Memorandum to the City of Markham Committee of Adjustment

File: A/051/20
Address: 3 Sir Ector Court – Markham, ON
Applicant: Sasha Lazarou
Agent: Building Experts Canada Ltd.
Hearing Date: November 18, 2020

The applicant is requesting relief from the following requirements of the “Residential One (R1) Zone” under By-law 1229, as amended (“the By-law”), as it relates to the proposed construction of a new two-storey detached dwelling, to permit:

DRAWING TITLE:
SITE PLAN

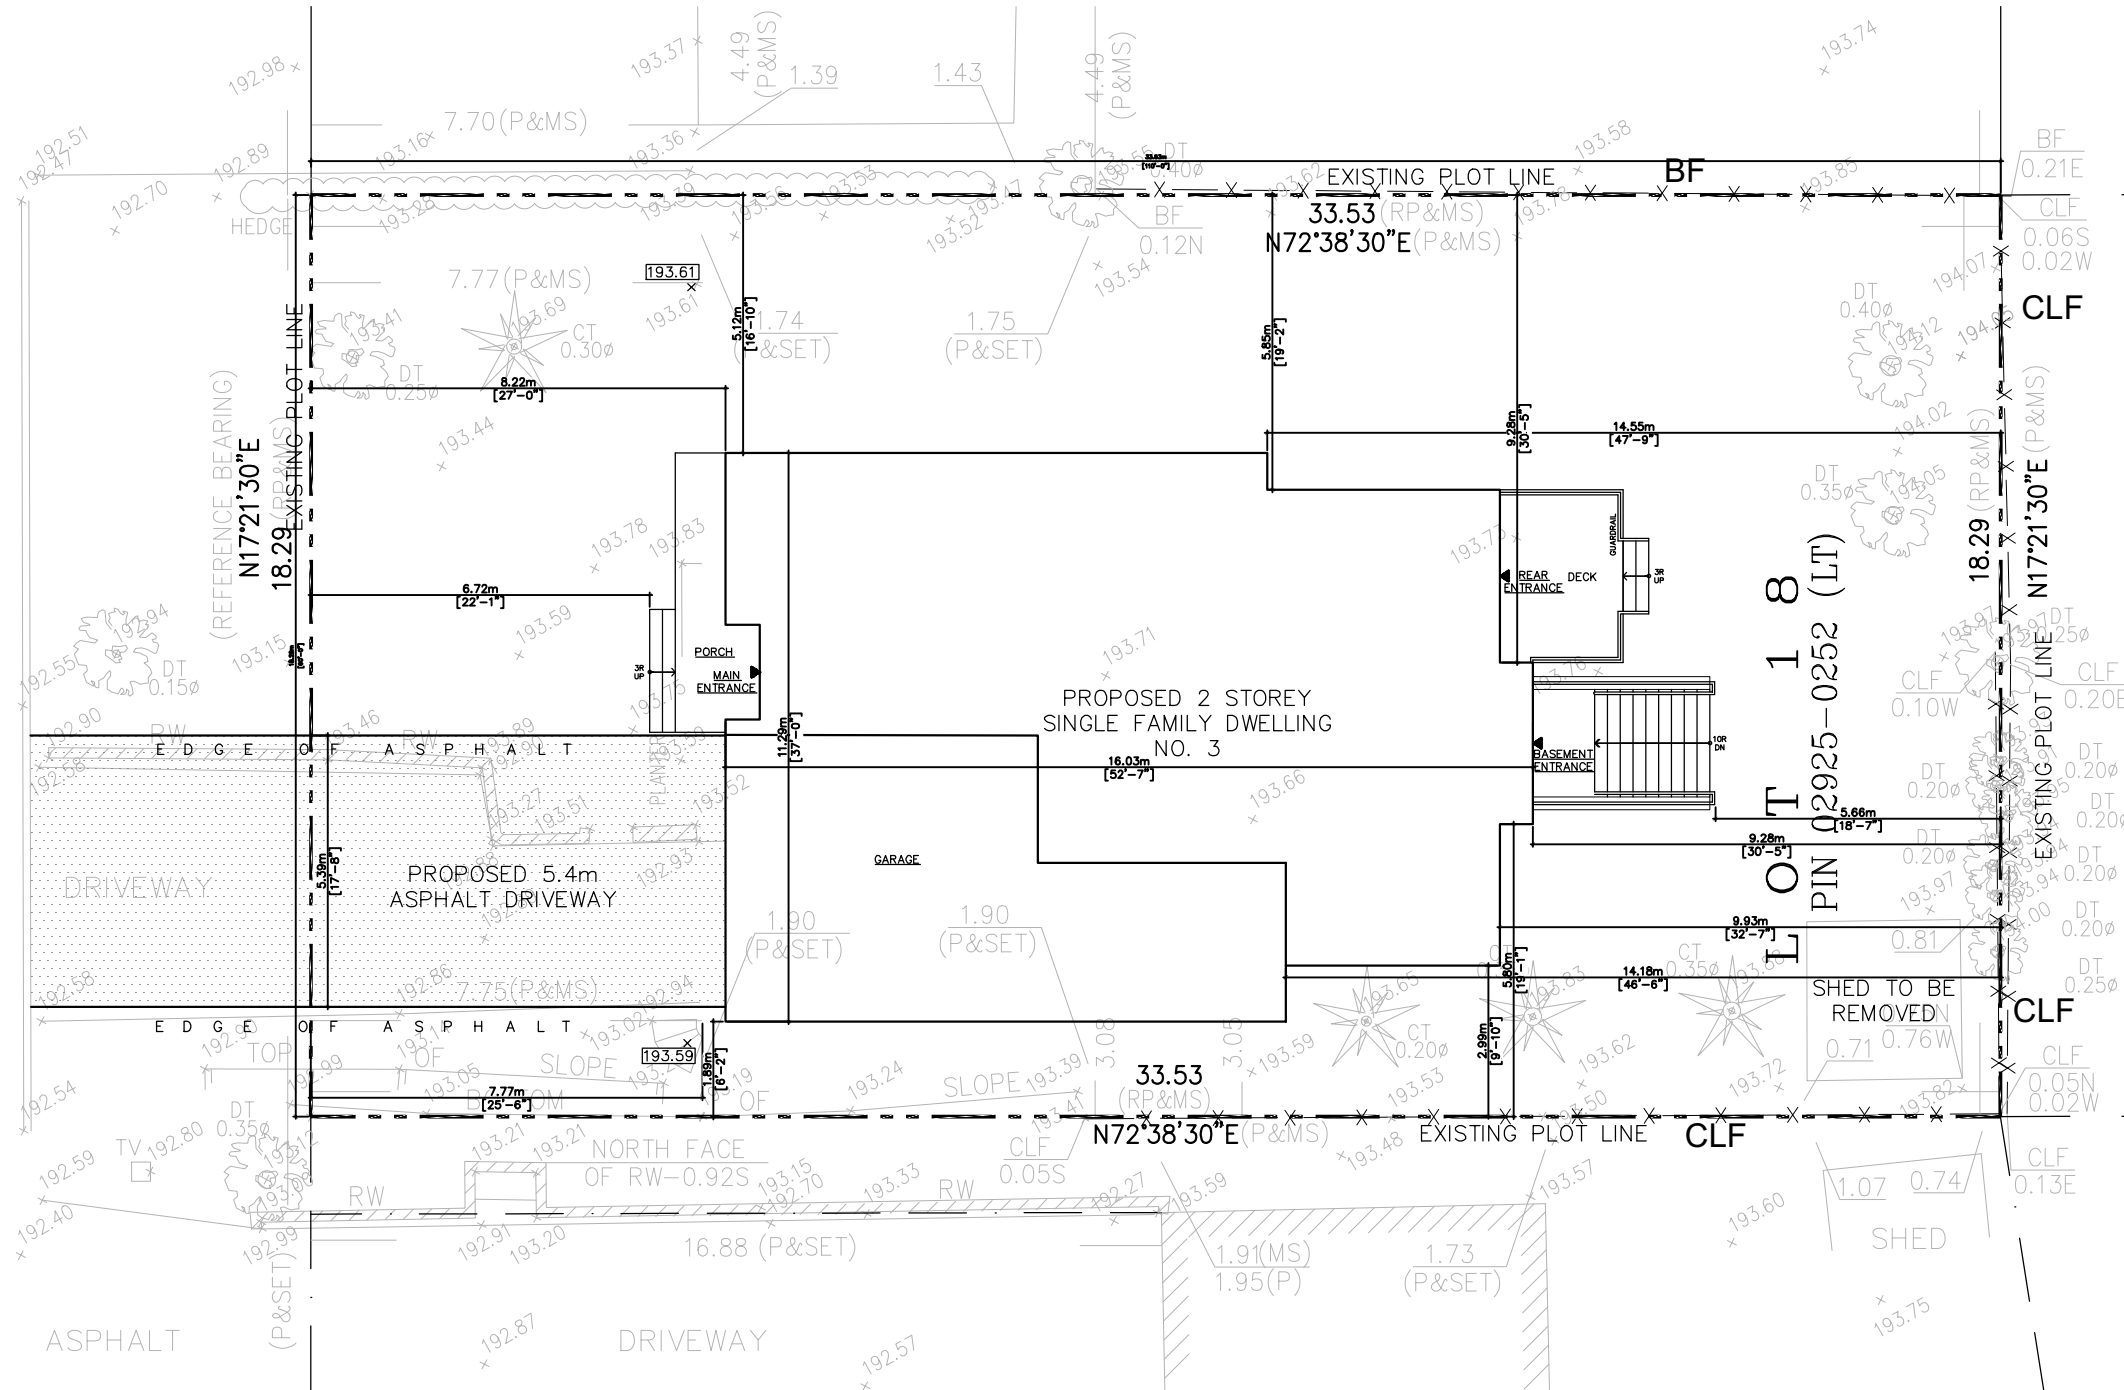
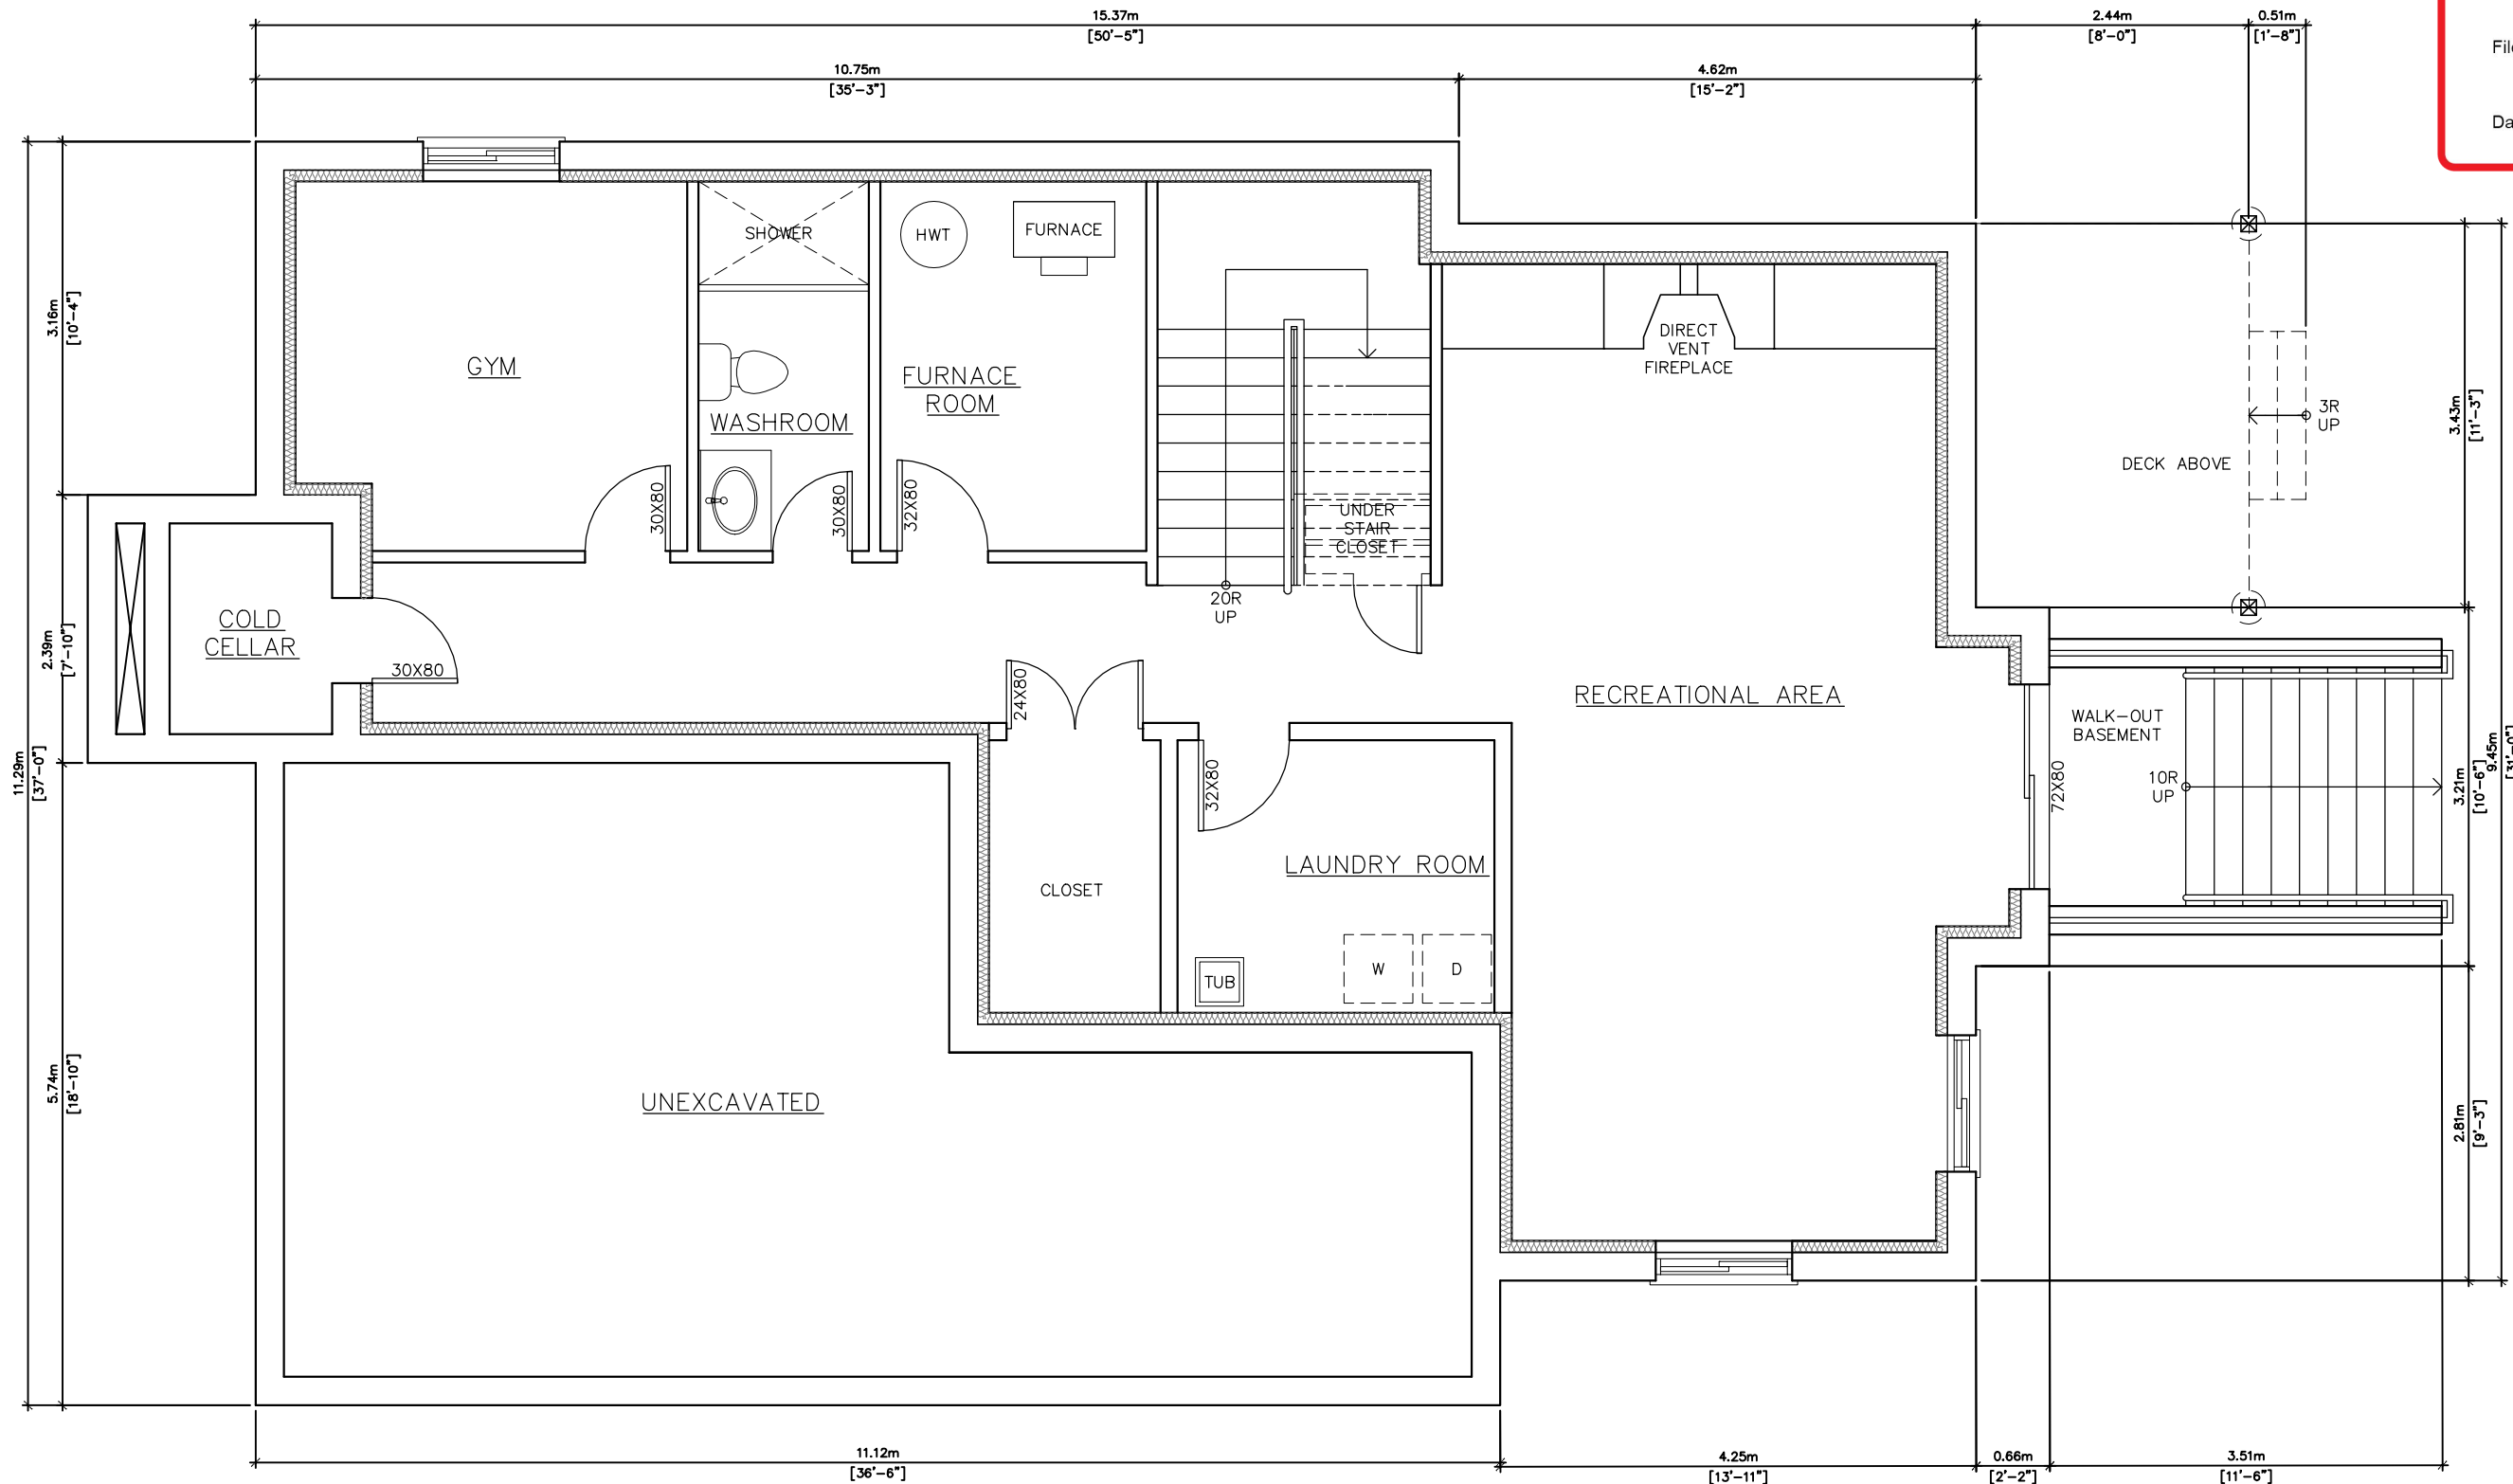
- the floor area ratio appears to not include the internal stairs area within the dwelling; and
- the stairs shown in the rear yard may require an additional variance to permit them to encroach within the required rear yard setback.

Staff also remind Committee that the plans submitted (Appendix "B") may not correctly reflect the proposed floor area ratio, and that an additional variance may be required to permit stairs to encroach within a required rear yard setback. The applicant has requested this application to proceed. However, staff consider it appropriate to defer this application so that the applicant can resolve these technical matters, and ensure any approved variances accurately reflect the proposed development.
